SUBJECT: DAVIS-BESSE NUCLEAR POWER STATION, UNIT 1 - STAFF ASSESSMENT OF INFORMATION PROVIDED PURSUANT TO TITLE 10 OF THE *CODE OF FEDERAL REGULATIONS* PART 50, SECTION 50.54(f), SEISMIC HAZARD REEVALUATIONS FOR RECOMMENDATION 2.1 OF THE NEAR-TERM TASK FORCE REVIEW OF INSIGHTS FROM THE FUKUSHIMA DAI-ICHI ACCIDENT (TAC NO. MF3728)

STAFF ASSESSMENT BY THE OFFICE OF NUCLEAR REACTOR REGULATION

RELATED TO SEISMIC HAZARD AND SCREENING REPORT

DAVIS-BESSE NUCLEAR POWER STATION, UNIT 1

**Figure 3.3- 1 Plot of Staff's and Licensee's Base Case Shear-Wave Velocity Profiles for the Davis-Besse site**

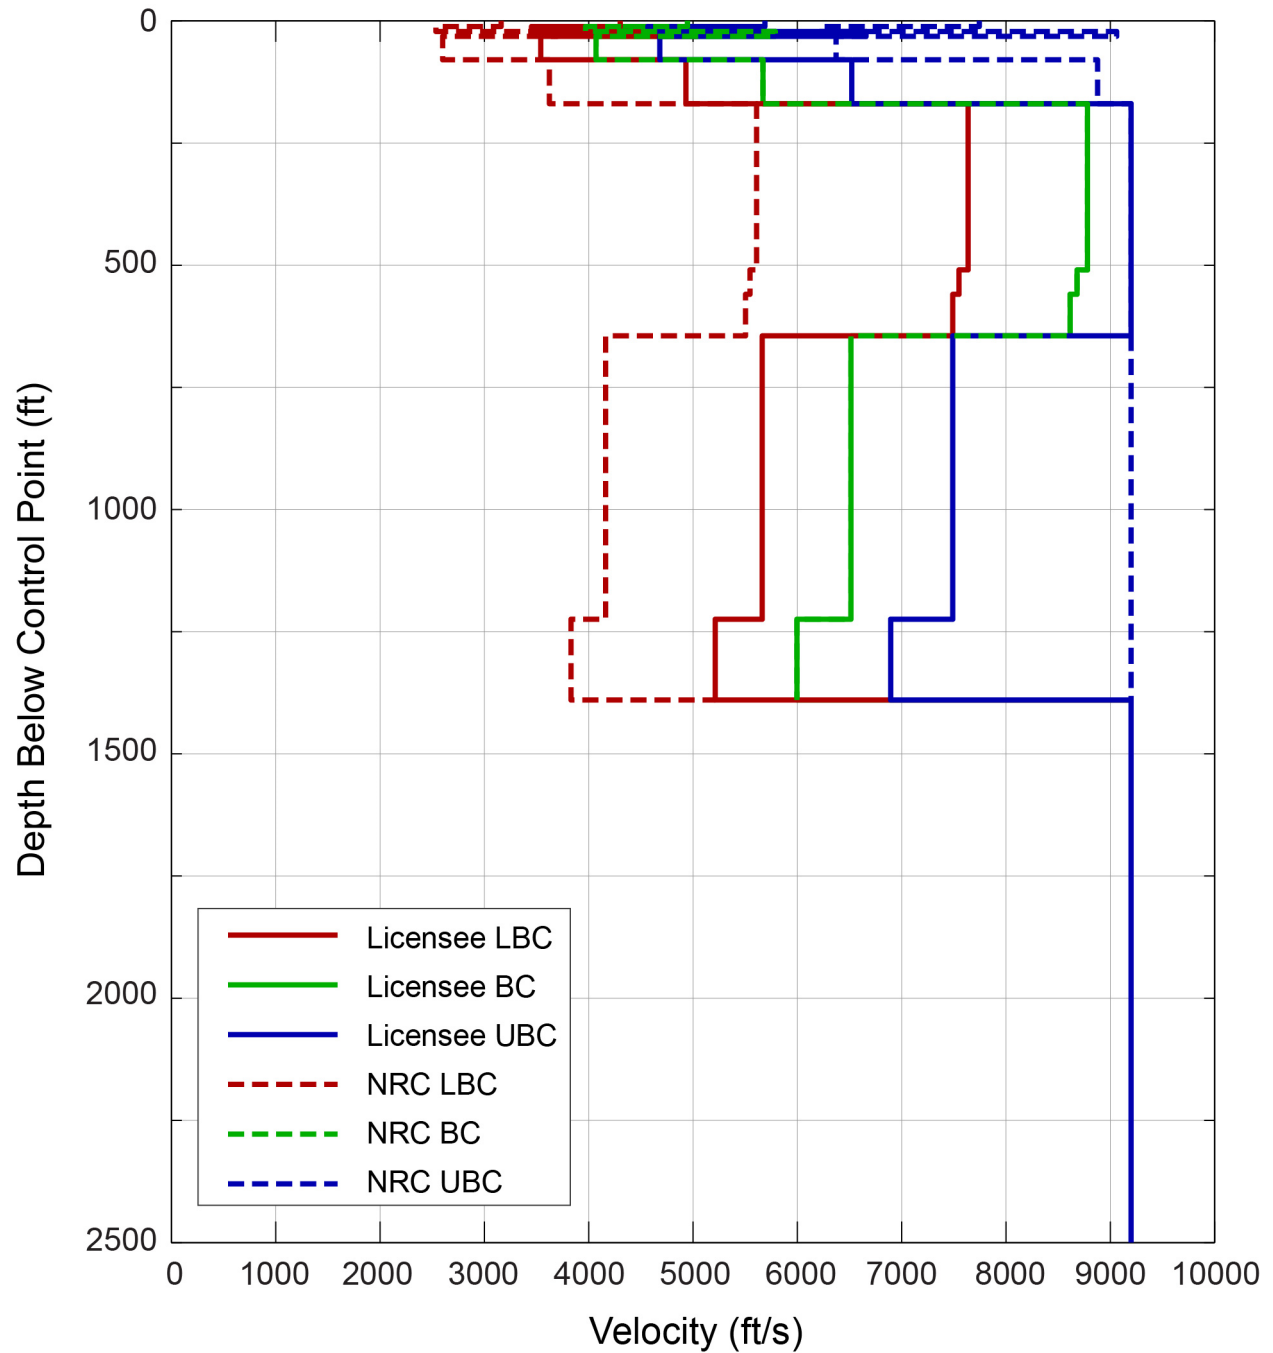
To capture the uncertainty in the shear wave velocity profile due to the limited on-site measurements for the upper layers and use of regional data rather than on-site measurements for the deeper layers, the licensee developed three base case velocity profiles. Table 2-4 of the SHSR provides the licensee's shear-wave velocity profiles (P1, P2, P3). To develop the best estimate for base case shear-wave velocity profile, the licensee set the initial shear-wave velocity at the SSE control point (at an elevation of 540 ft [165 m] MSL) to 4948 ft/s [1508 m/s]. According to the SHSR, based on the well-characterized nature of the flat-lying geologic unit beneath the site, the licensee used a factor of 1.15 (natural-log standard deviation of 0.11) to obtain the upper and lower range velocity profiles. Figure 3.3-1 of this assessment shows the three base case profiles developed by the licensee.

Because the licensee used on-site geophysical measurements and rock cores to estimate the shear wave velocities for the upper rock layers and nearby well log data to estimate the velocities for the deeper layers, the staff adopted the licensee's best estimate base case profile (P1) as its middle base case profile. However, due to the limited amount of on-site geophysical measurements and the use of off-site well log data, the staff used a natural-log standard deviation of 0.35, instead of the licensee's value of 0.11, to develop its lower and upper velocity profiles. The licensee used a lower standard deviation due to the generally flat lying geologic units and the availability of nearby well log data; however, the staff concluded that a somewhat higher standard deviation was warranted since the closest well log is 2-3 miles from the site. As a result, as shown in Figure 3.3-1 of this assessment, the NRC staff's lower and upper velocity profiles are farther from the middle or best estimate profile than the licensee's lower and upper profiles. To characterize the dynamic material behavior of the site response profile, the staff used the same approach as the licensee, which is described above in Section 3.3.1 of this assessment.

**Figure 3.3- 2 Plot Comparing the Staff's and the License's Median Amplification Functions and Uncertainties for two input loading levels for the Davis-Besse site**

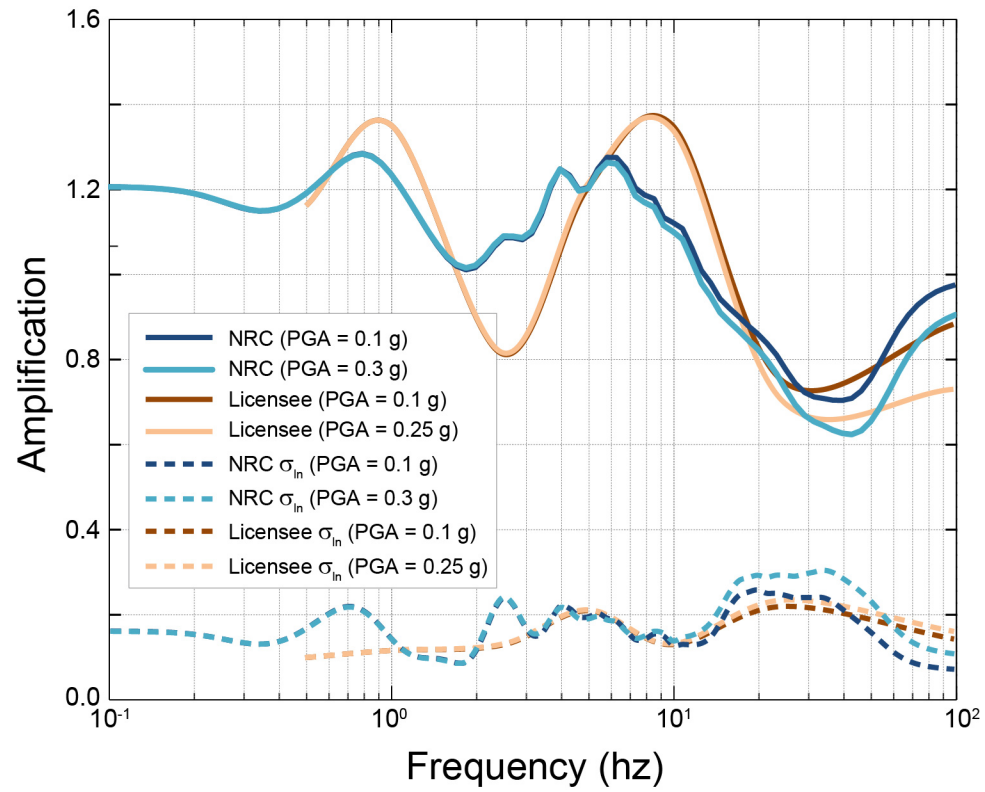
Figure 3.3-2 of this assessment shows a comparison of the NRC staff's and the licensee's median site amplification functions and uncertainties ( $\pm 1$  standard deviation) for two of the eleven input loading levels. As shown in this figure, the licensee's amplification functions peak at around 0.9 Hz and 8.5 Hz, with a trough at 2.5 Hz. The two peaks could approximately be associated with resonance in two columns of firm rock above the crystalline basement with thicknesses of about 1390 ft [424 m] and 170 ft [52 m], respectively. The NRC amplification functions are on average slightly lower than those of the licensee, with resonance frequencies shifted to lower values. The differences in amplification function values are mainly due to

differences in the choice of velocity profiles rather than in differences between the licensee and NRC analysis methods.

Figure 3.3-2 of this assessment shows a comparison of the NRC staff's and the licensee's median site amplification functions and uncertainties ( $\pm 1$  standard deviation) for two of the eleven input loading levels. The amplification functions are highest at frequencies of less than 1 Hz and decrease with increasing frequency. Amplification functions calculated by the NRC staff and the licensee are similar, however uncertainties are higher for the staff's profiles. This is due to the greater epistemic uncertainty in the staff's kappa values and damping parameters.

**Figure 3.3-3 Plot Comparing the Staff's and the Licensee's Mean Control Point Hazard Curves at a Variety of Frequencies for the Davis-Besse site**

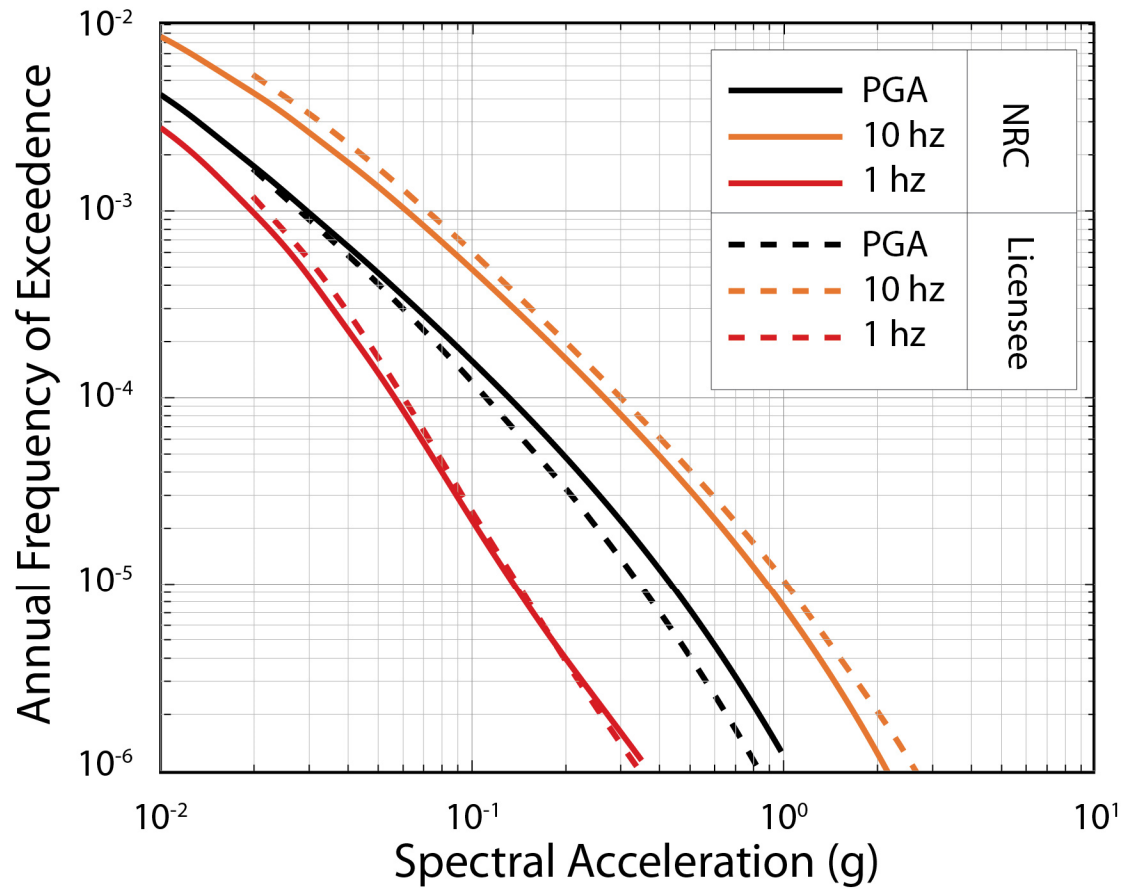
The licensee's approach to modeling the subsurface rock properties and their uncertainty results in similar site amplification factors to those produced by the NRC staff. As shown in Figure 3.3-3 of this assessment, minor differences in site amplification and uncertainty have a very minor impact on the control point seismic hazard curves and the resulting GMRS, discussed below. Appendix B of the SPID provides guidance for performing site response analyses, including capturing the uncertainty for sites with less subsurface data; however, the guidance is neither entirely prescriptive nor comprehensive. As such, various approaches in performing site response analyses, including the modeling of uncertainty, are acceptable for this application.

**Figure 3.4-1 Comparison of the Staff's GMRS with Licensee's GMRS and the SSE for the Davis-Besse site**

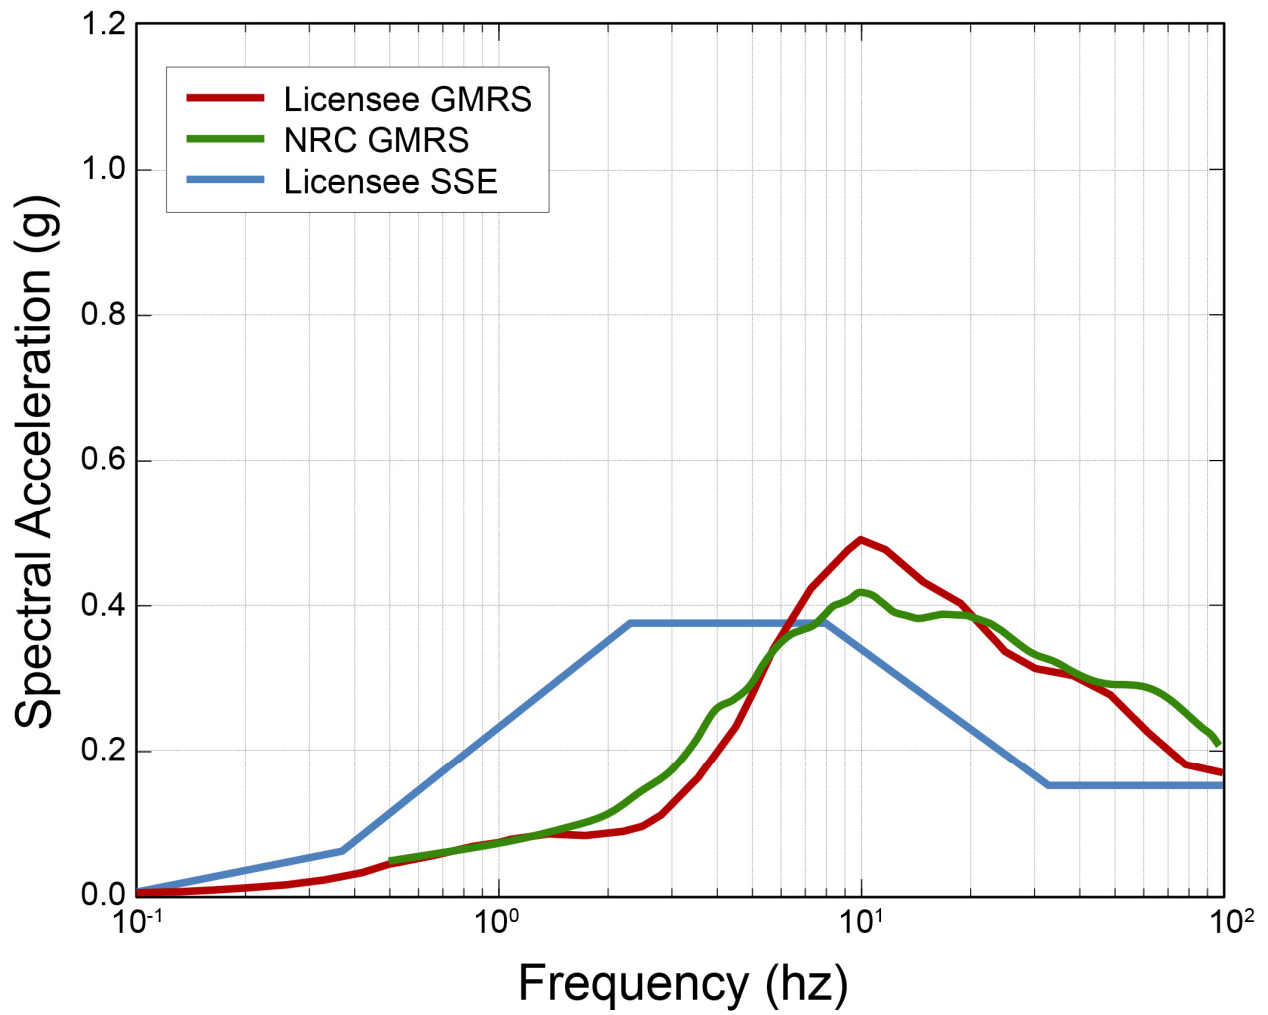
The NRC staff independently calculated  $10^{-4}$  and  $10^{-5}$  UHRs using the results of its confirmatory PSHA and site response calculations, as described in Sections 3.2 and 3.3 of this staff assessment, respectively. Figure 3.4-1 of this staff assessment shows a comparison of the GMRS determined by the licensee to that determined by the NRC staff.

As shown in Figure 3.4-1, the licensee's and NRC staff's GMRS shapes are generally similar with the peak occurring at similar frequencies. The licensee's GMRS is higher than the NRC staff's confirmatory analysis at frequencies between 6 and 20 Hz, but lower elsewhere. As described above in Section 3.3, the NRC staff concludes that these minor differences over this frequency range are primarily due to the differences in the site response analyses performed by the licensee and staff.

50.54(f) letter. The NRC staff performed both a PSHA and site response confirmatory analysis, and achieved results consistent with the licensee's horizontal GMRS. As such, the NRC staff concludes that the GMRS determined by the licensee adequately characterizes the reevaluated hazard for the DBNPS site. Therefore, this GMRS is suitable for use in subsequent evaluations and confirmations, as needed, for the response to the 50.54(f) letter.
